SR0-304
March 1982

DRAFT

**SYSTEMATIC EVALUATION PROGRAM
STRUCTURAL REVIEW OF THE
OYSTER CREEK NUCLEAR POWER PLANT
DRYWELL CONTAINMENT STRUCTURE
UNDER COMBINED LOADS**

Figure 9. Drywell gross structural discontinuity and local primary membrane regions.

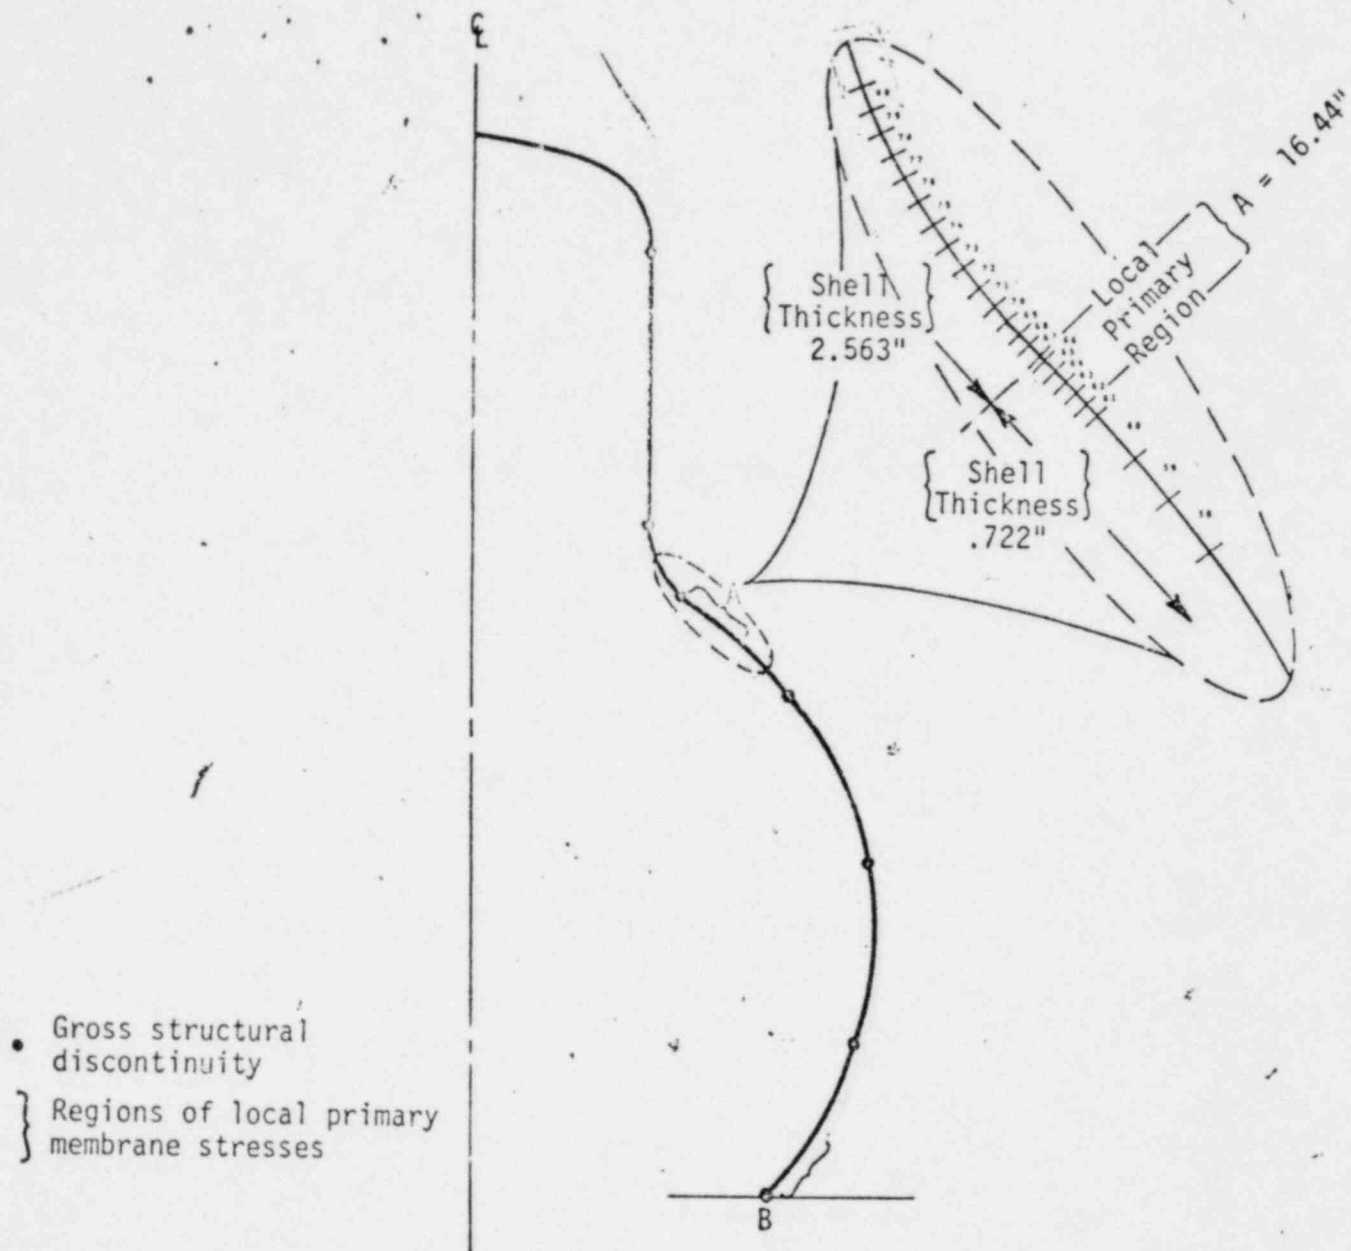
After combining maximum stresses produced at various locations of the drywell, it was determined that the critical location for Design Conditions was where the sphere curves inwards to the cylindrical section (Region A on Figure 9). The critical location for Service Conditions is at the base of the drywell. Table 2 includes maximum general membrane stresses; Tables 3 and 4 present the stress values used for ASME Code Design condition compliance for local primary membrane regions. Table 5 is for Service Level compliance.

The sum of general membrane stresses (P_m) listed in Table 2 do not meet the general primary membrane stress intensity requirements of $P_m \leq 1.0 S_m$. The region where the general primary membrane stresses exceed the allowable is immediately adjacent to the local primary region (Region A of Figure 9). Even the most lenient interpretation of the local primary region would require that the local primary region be extended approximately 11 in. upwards before the general membrane stress profile in this region would drop below the $1.0 S_m$ value. The local membrane stress intensity, primary membrane stress intensity, and primary plus secondary stress intensity shown in Tables 3, 4, and 5 respectively all meet the stress intensity limits specified by the ASME Code. It should be noted that the

Figure 11. Pressure results (psi).

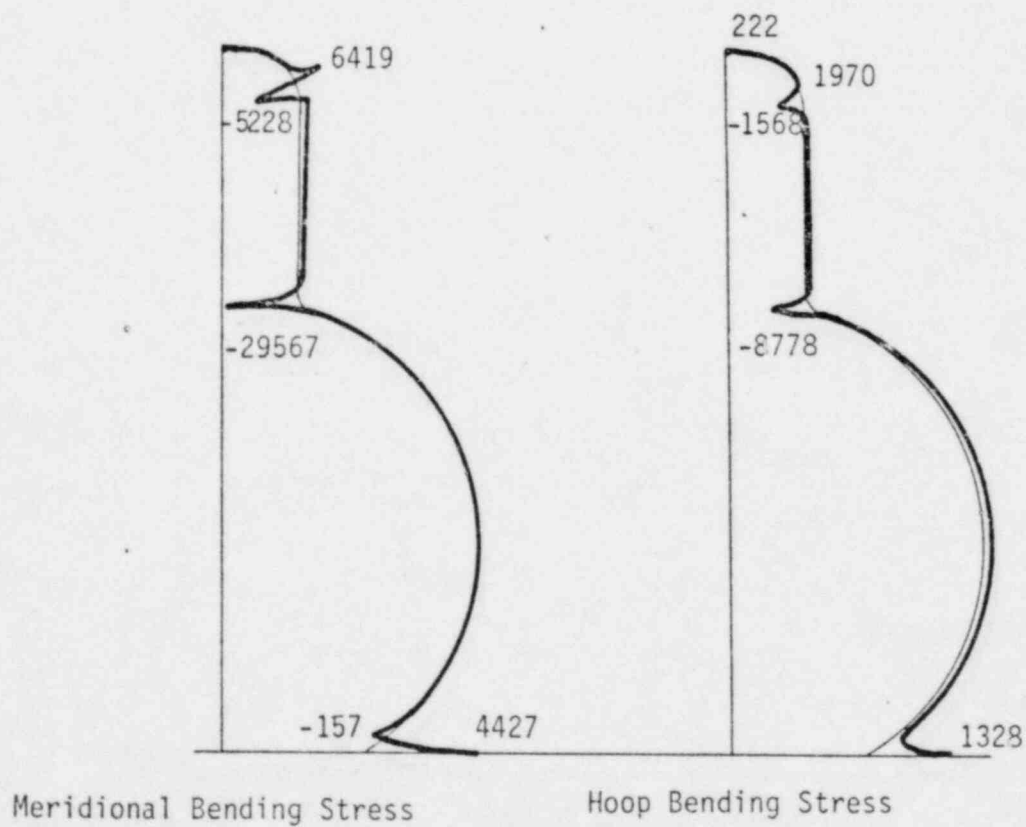
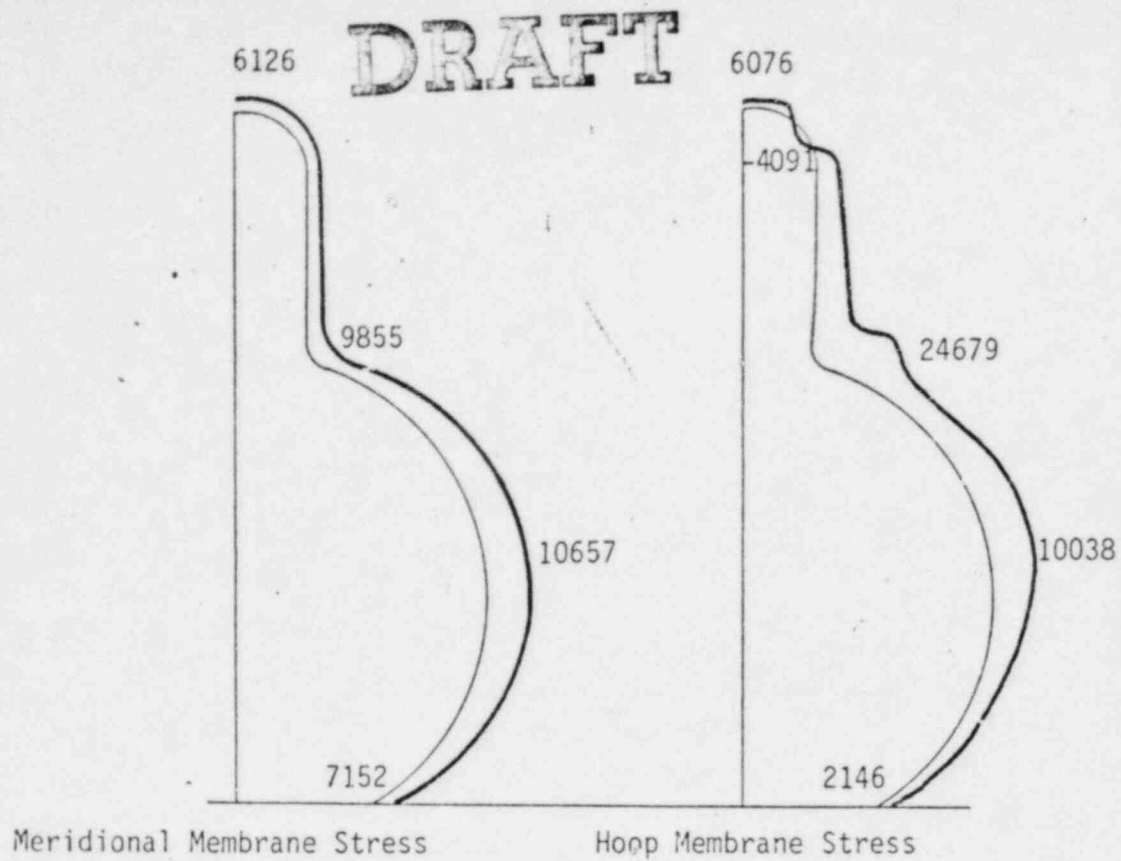
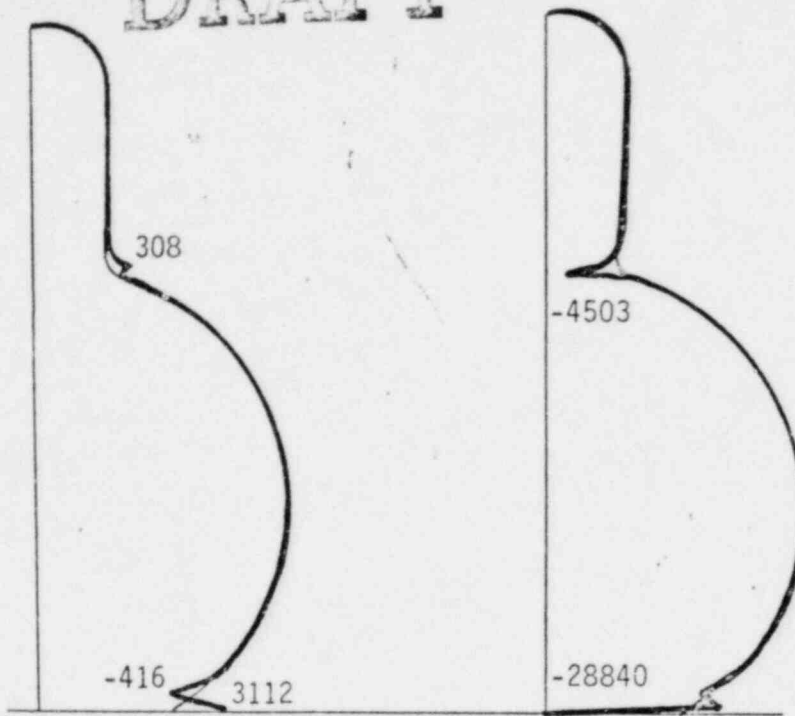
large meridional and hoop bending stresses illustrated in Figure 11 are classified as secondary stresses because they are caused by a gross structural discontinuity, but these bending stresses combined with the membrane stresses will produce a stress intensity of 39.4 ksi that exceeds the minimum yield stress of the material.
